Attachment E to  
Comments of AGA, et al.  
Docket No. EERE-2017-BT-STD-0019  
RIN 1904-AD91  
Filed May 16, 2022

**Comments on the U. S. Department of Energy, “Notification of Availability of Preliminary Technical Support Document [pTSD] and Request for Comment [EERE–2017–BT–STD–0019] RIN 1904–AD91**

**May 16, 2022**

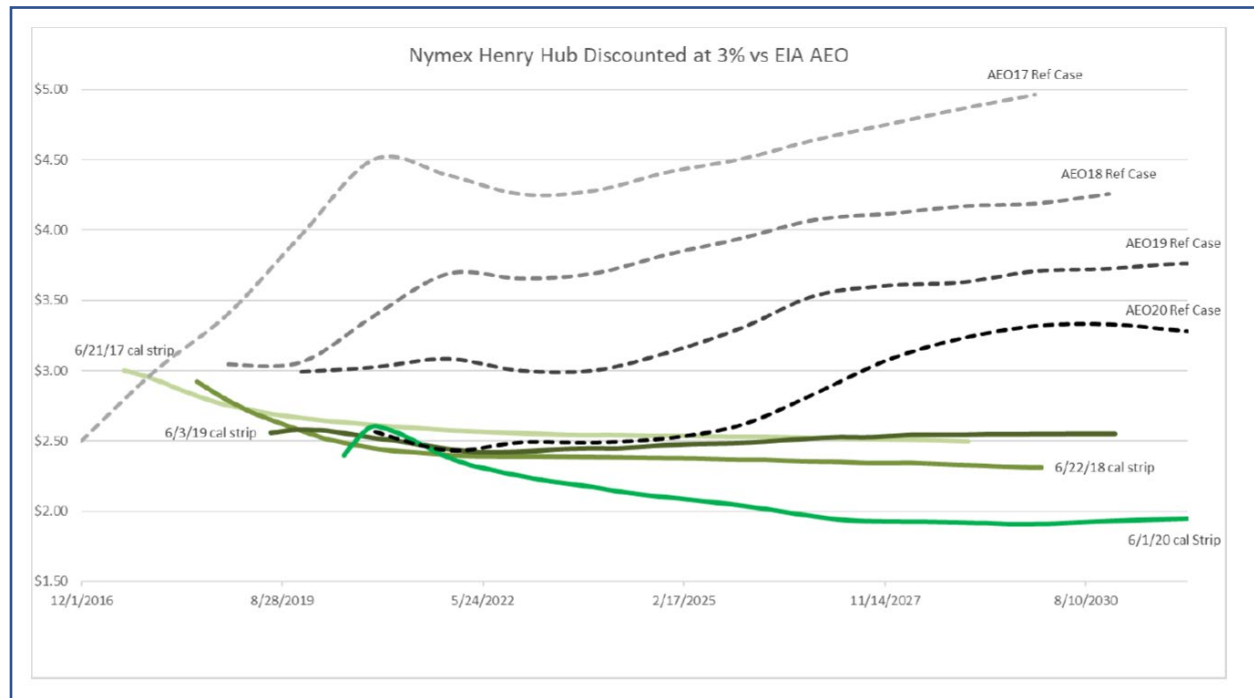
Consumer energy prices. Where the Department’s spreadsheet relies heavily upon distributional data inputs to the Monte Carlo analysis of life cycle cost and paybacks, the Department uses single time series average and marginal consumer energy price forecasts for consumer electricity and gaseous fuels to support the pTSD analysis. Ironically and historically, consumer energy price forecasts from the U. S. Energy Information Administration (EIA) have been shown to be unreliable from forecasting year to forecasting year, with diminishing accuracy and reliability in out years of the forecast period. Shown below is a record of EIA Henry Hub natural gas prices from successive editions of the “Annual Energy Outlook, Reference Cases” from 2017 through 2020.<sup>12</sup>

As shown, successive forecasts reported in the Annual Energy Outlook (AEO) show overprediction of natural gas prices over time. Since the spreadsheet currently reports results for prices used from the AEO, 2021 edition, it can be expected that once again the prices forecasted and used in the analysis overpredict prices to expect in the future and against future forecasts. Additionally, the “Energy Price Trends” reported in the spreadsheet show systematic increases in natural gas prices in the future, including a 36% increase between 2020 to 2050 and an annual increase of 0.37% per year in the years following 2050. At the same time, the trends reported for electricity show prices changing between a decline of 6% and a rise of 6% between 2020 and 2050 and declines of between 0.46% and 0.85% annually in the years following 2050. For analysis of gas-fired consumer water heaters, these trends and disparities work to overstate the LCC savings and paybacks for higher efficiency minimum efficiency standards for natural gas alternatives, and it is expected that similar biases to exist for propane consumer water heaters.

**RECOMMENDATION:** The Department should, as a minimum measure, augment its current use of single time series forecasts of average and marginal consumer energy prices with forecast adjustments to account for forecasting errors and upward bias on natural gas prices and run the analysis under the resulting alternative price forecast trends. For parity with forecasts of electricity prices, error factors of plus or minus 6% in forecast prices appears reasonable alternative price trends for natural gas and propane. Furthermore, a systematic adjustment in the AEO 2021 natural gas price out to 2050 and beyond is justified based on forecast history and there a downward adjustment in price growth on the order of 15% appears reasonable. These alternative prices should be run as sensitivity cases through the analysis to specifically document changes in consumer LLC savings and paybacks and to monitor changes in national savings associated with energy efficiency standards alternatives.
